PW033010-01
AGENDA ITEM MEMORANDUM

**RE: Item 60 continued from Apr. 19 Council meeting: Design Exception Appeal; Water Service
PLM Subdivision Phase 2C**

SUBJECT: Exception request, PLM Subdivision

PROJECT PLM Subdivision Phase 2C

Design Exception 3-8-2010
 Water Service in Public Sewer Easement

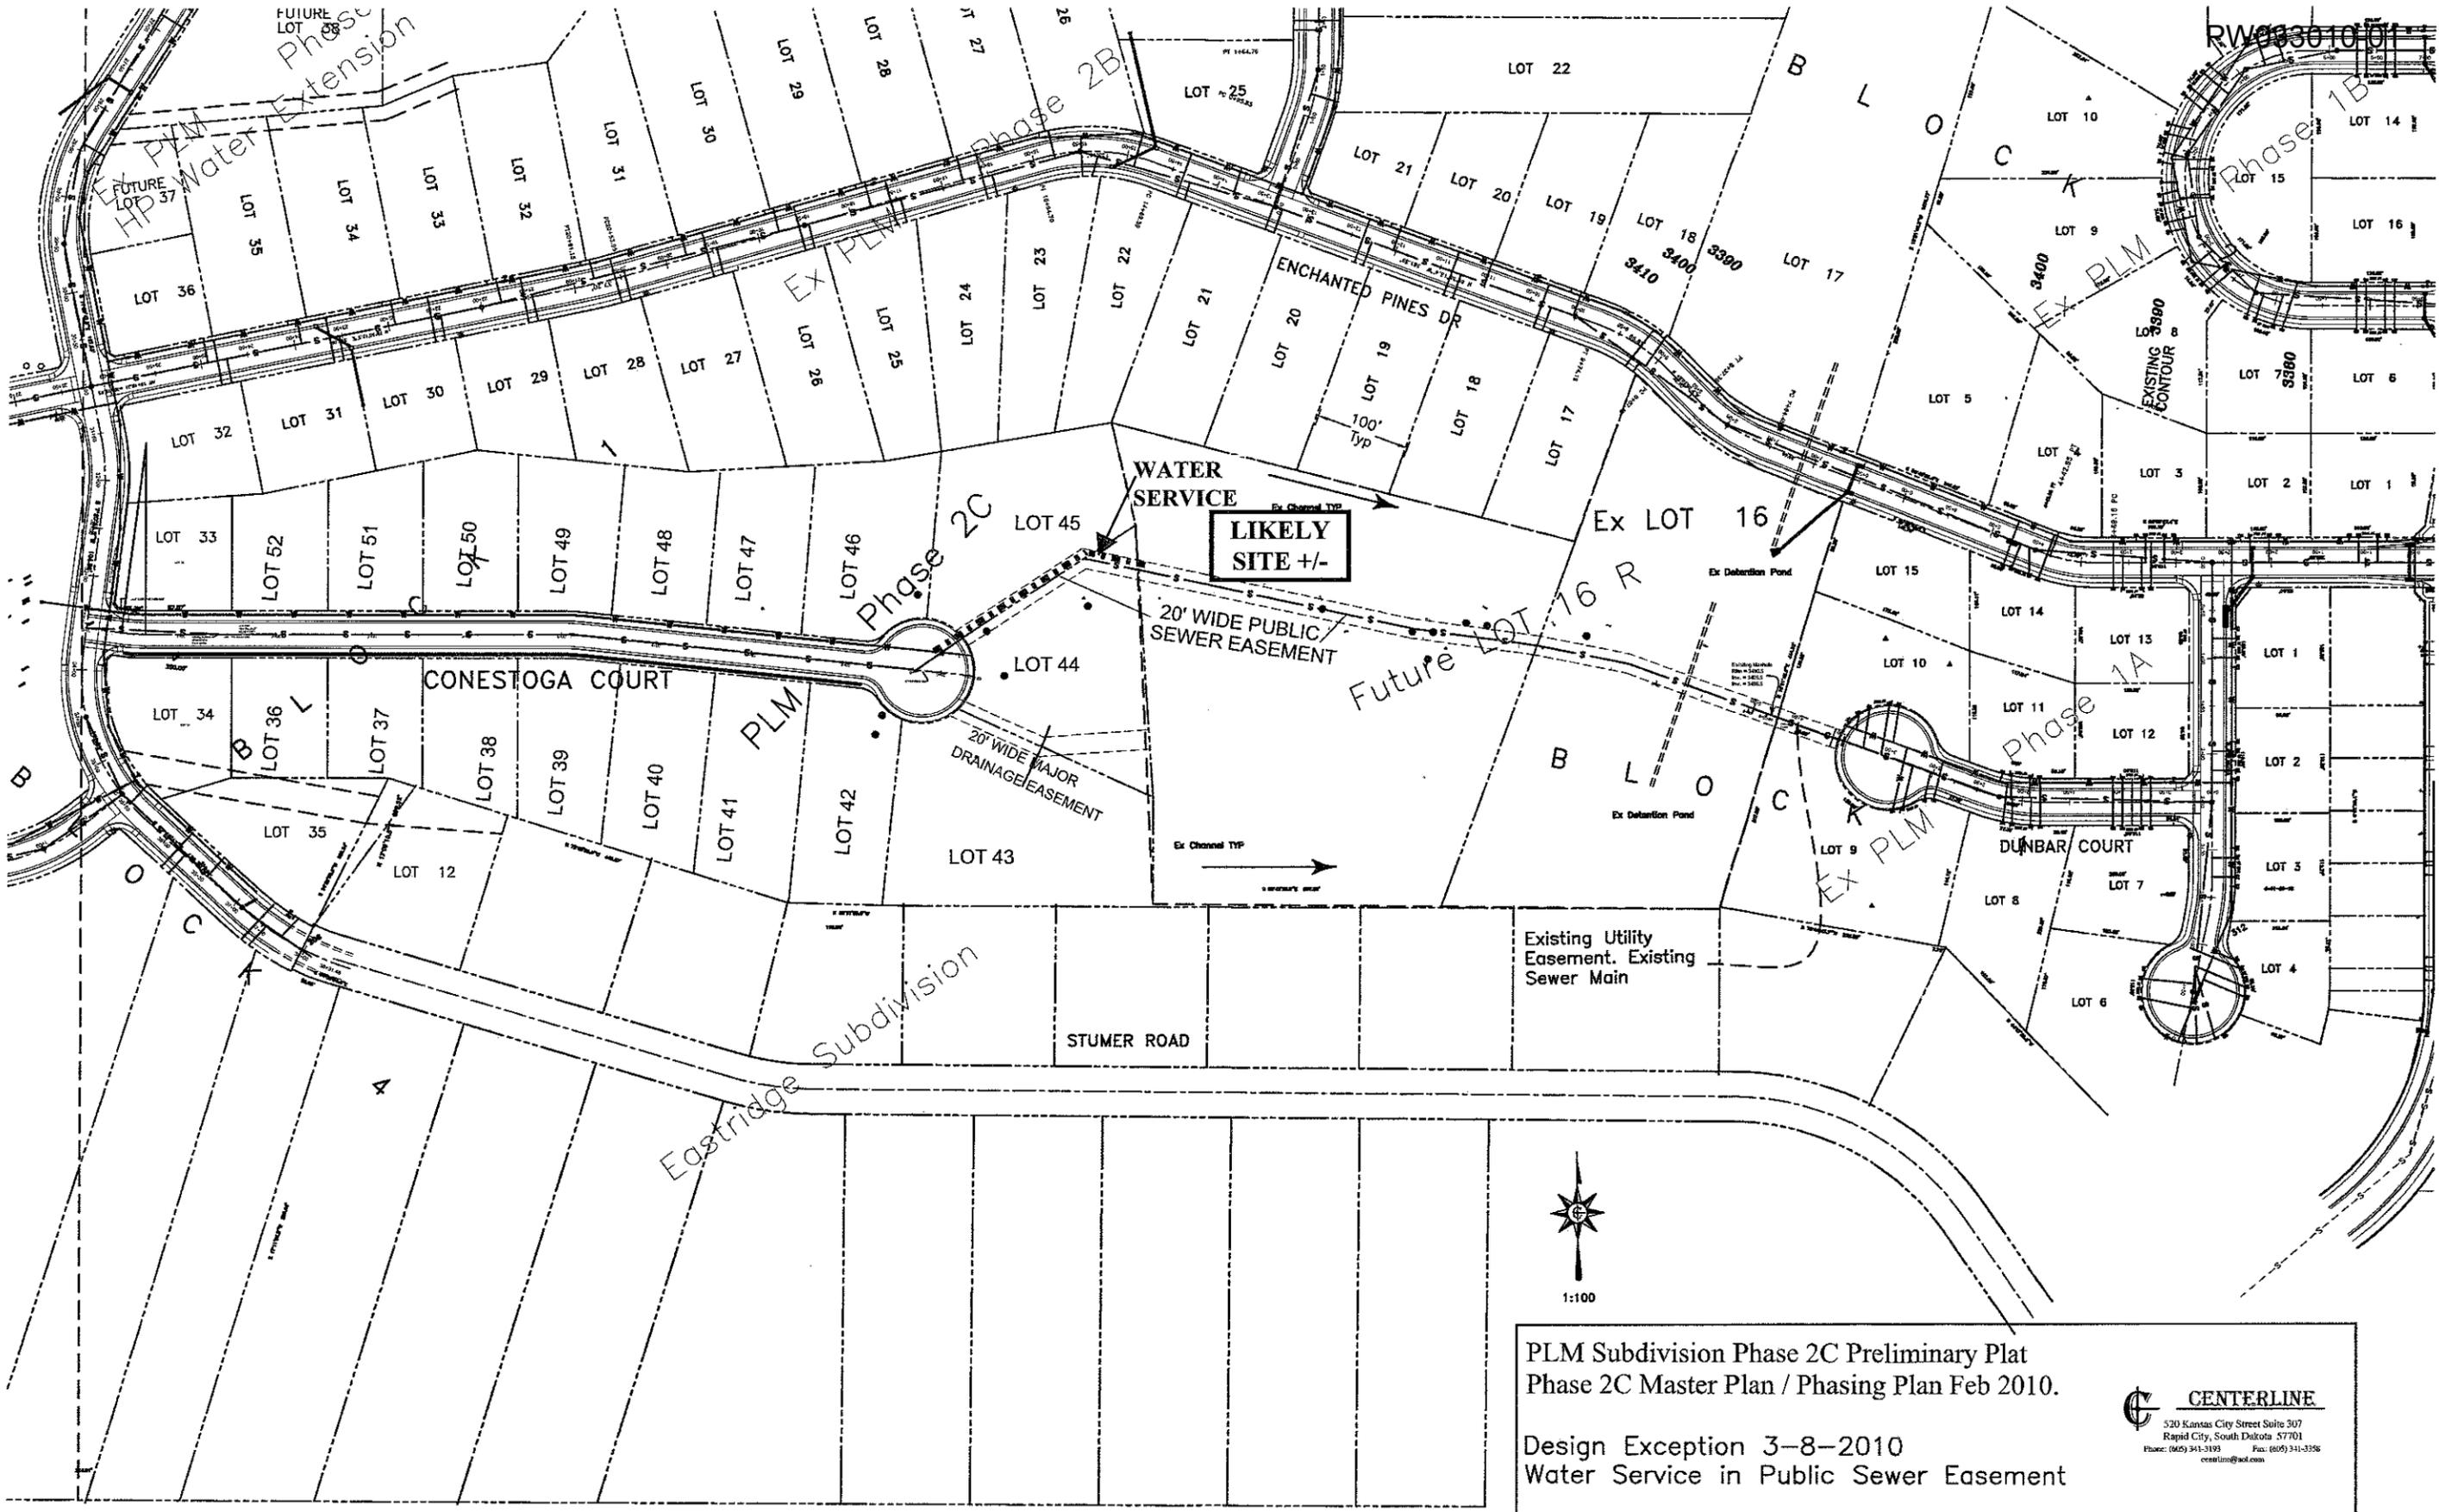
I have reviewed the exception request to allow a non conforming water service line across two proposed lots.

The information submitted by Centerline shows a proposed water service line to be extended in an existing 20' wide public sewer easement that is located on two proposed lots that adjoin the lot for which the service line is intended.

It is my opinion that the existing public sewer easement is not intended for a water service line and the installation of a service line within this easement may cause maintenance problems with the existing sewer main located within the easement. There are no extraordinary circumstances that exist that would support the installation of a non conforming water service line in this location. To preserve the ability to provide maintenance for the sewer main, the water service line should be located within its own easement if this exception request is approved by City Council.

Therefore, I recommend denial of the requested exception.

0+00 to 5+50
Sanitary Sewer
Plan and Profile

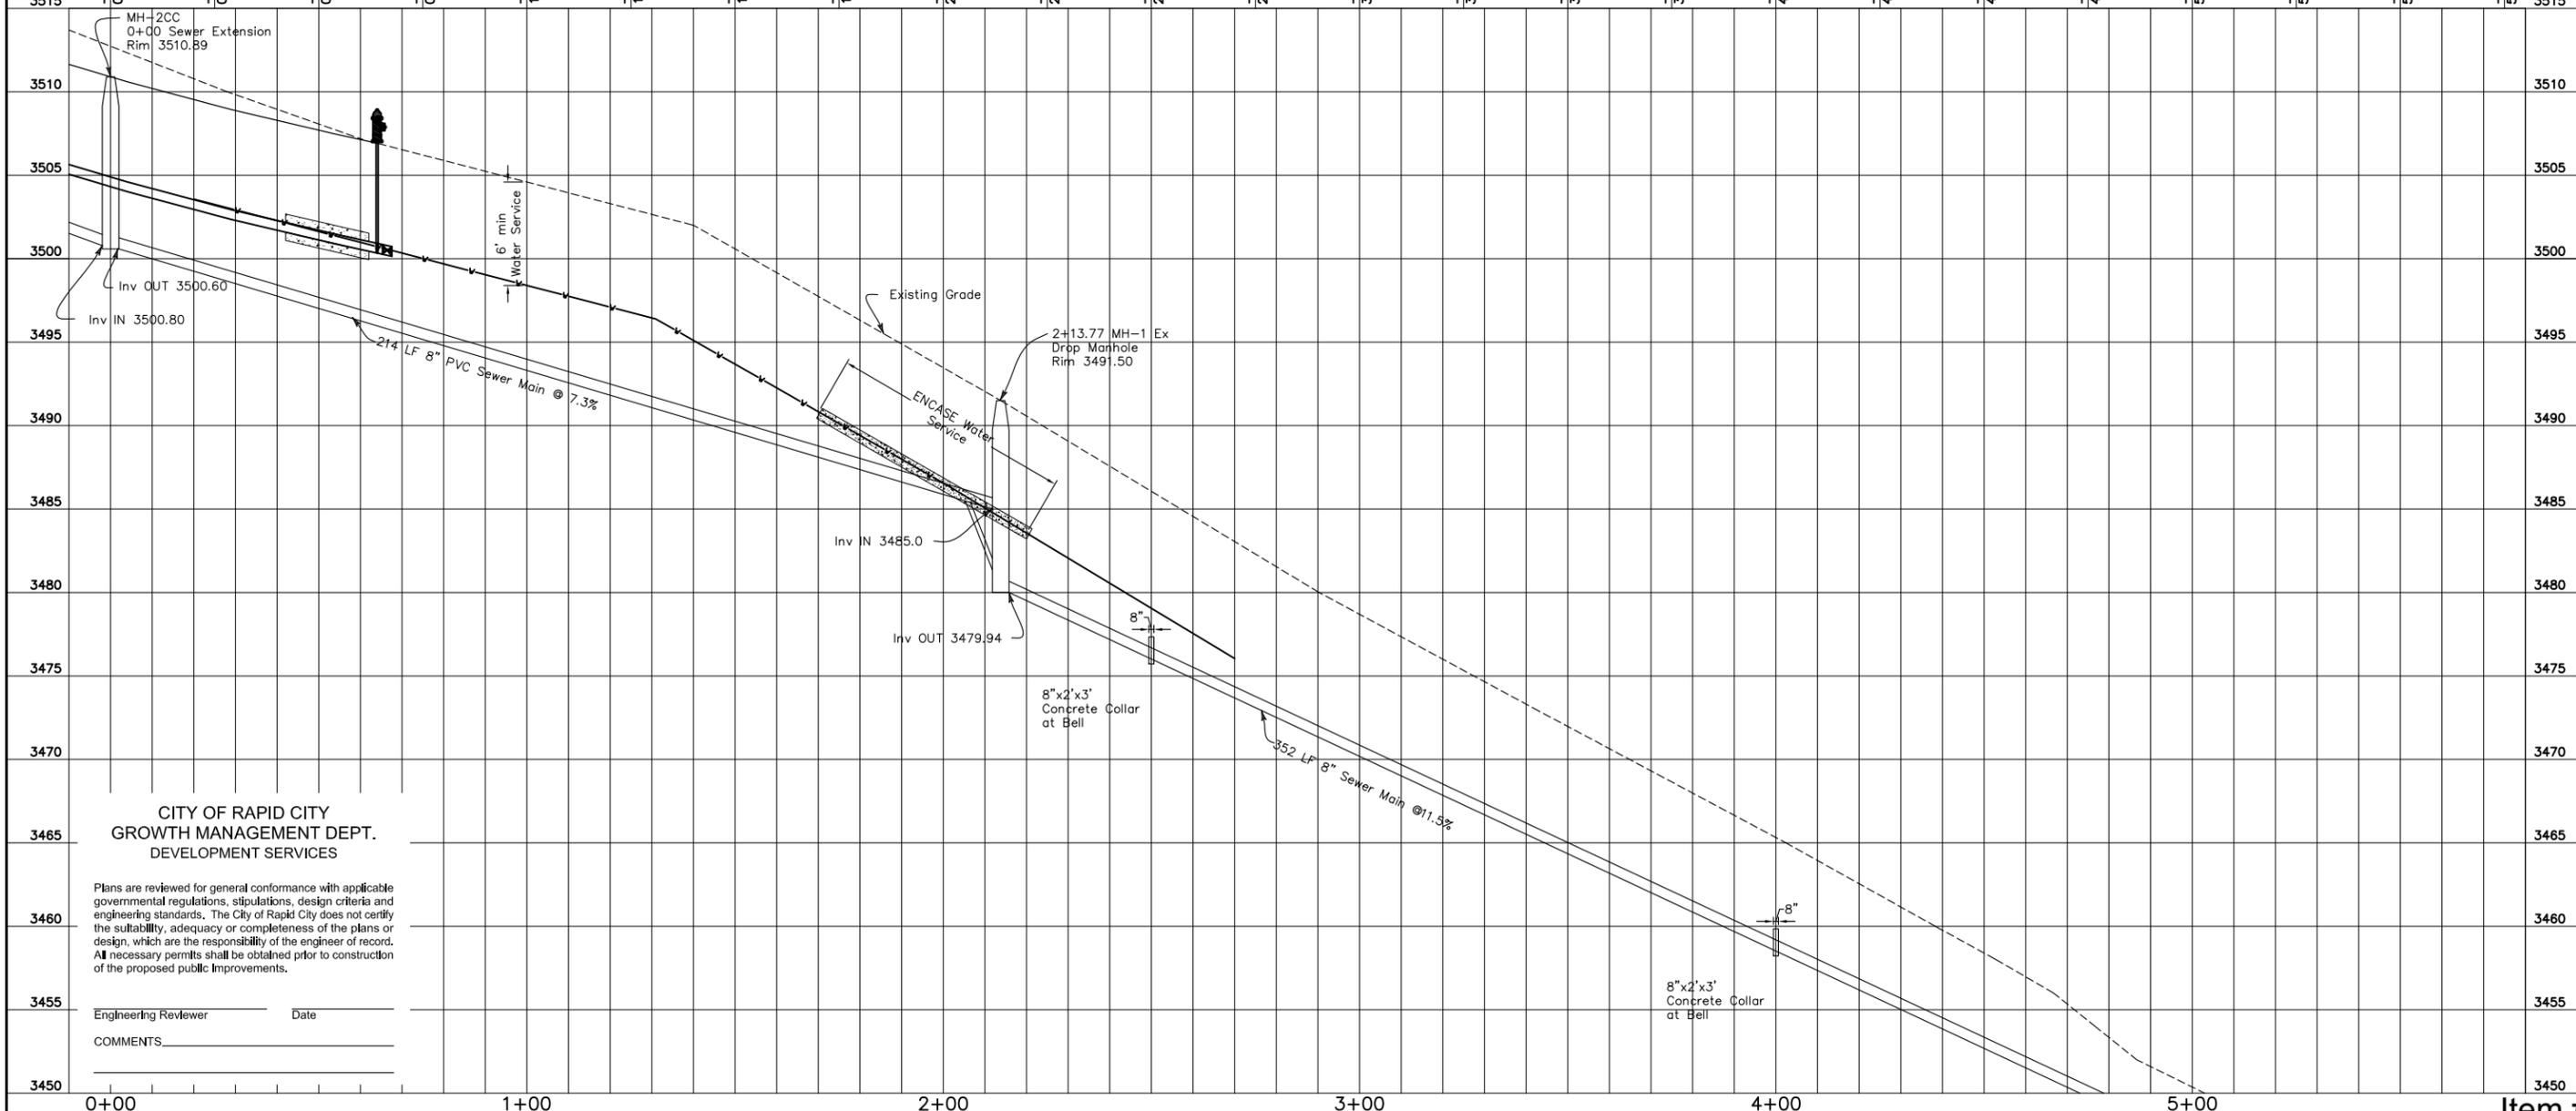
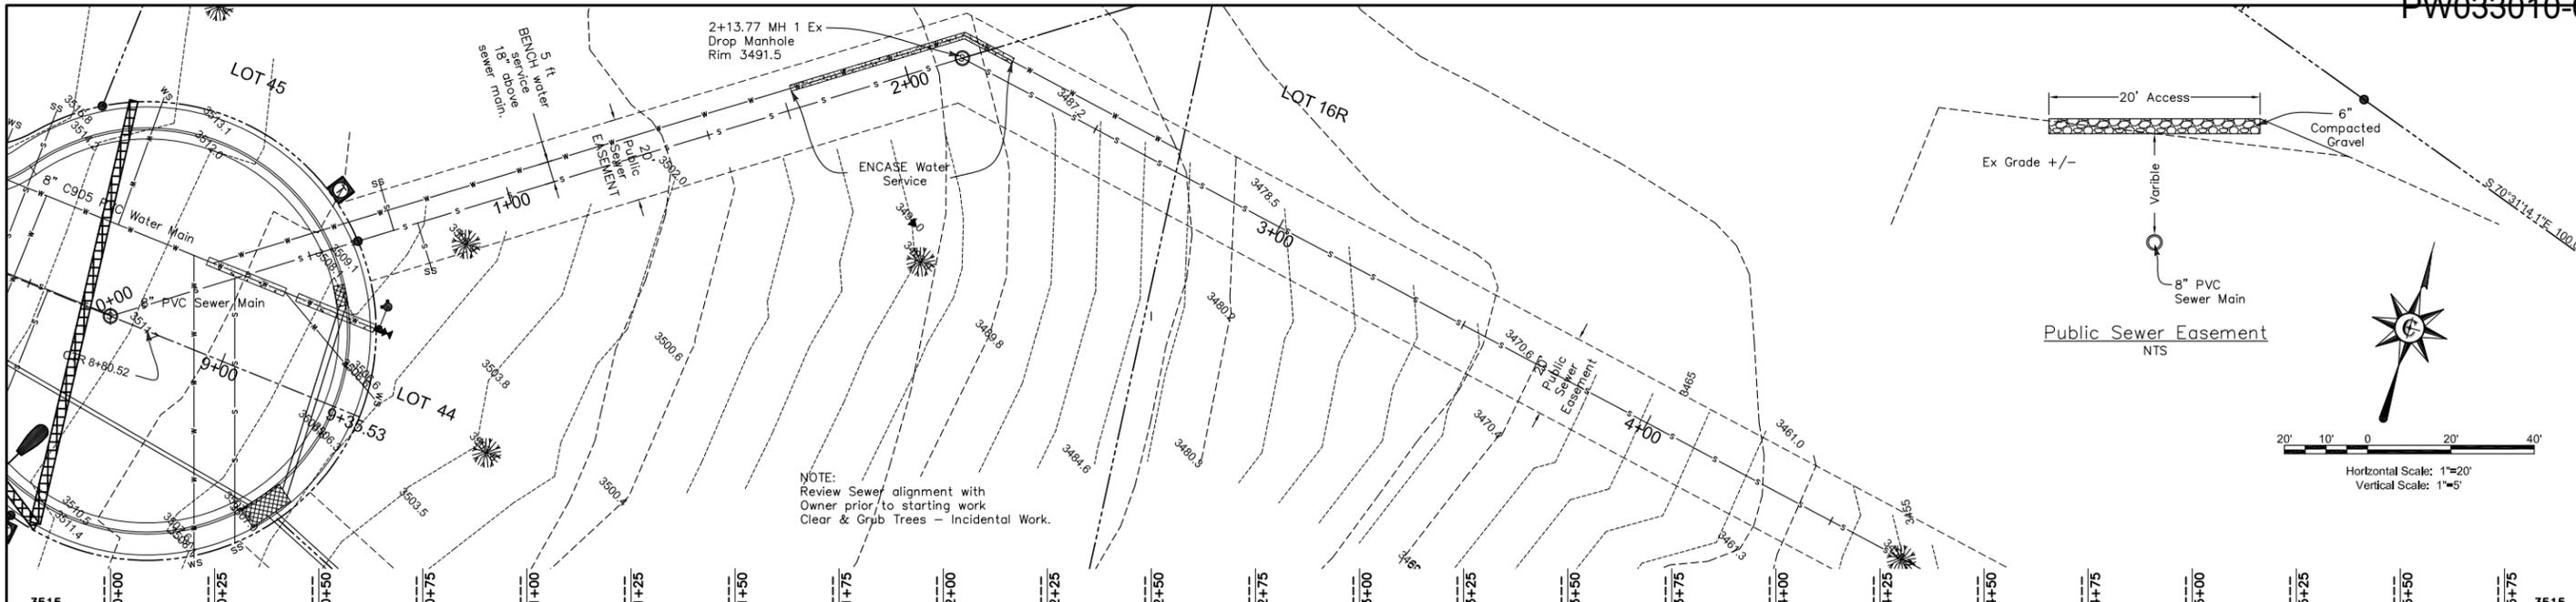
This request is nearly identical to the previously approved design exception for a water service in a sewer easement, except now at the west end.

After discussion with PLM Development, it became obvious that the most likely location for a home is at the west end of future 16R. Therefore, it was necessary to access a water pressure zone that would provide adequate pressure. The pressure zone serving Conestoga Court is correct for this proposed home site.

Placement is essentially no different from the previous request: ie., within the same easement provided for the sewer main. Also, Ten States Standards – the document that provides guidance for water systems – allows for benching water above sewer when horizontal distance is difficult to achieve.

In this instance the terrain constraints are as difficult as the east end, but will allow for a comfortable corridor following 10 States guidelines and encasing where necessary. The attached drawing illustrates the strategy.

PLM Development, LLC asks that you approve the placement of a water service line in the proposed easement in lieu of the previously approved exception.
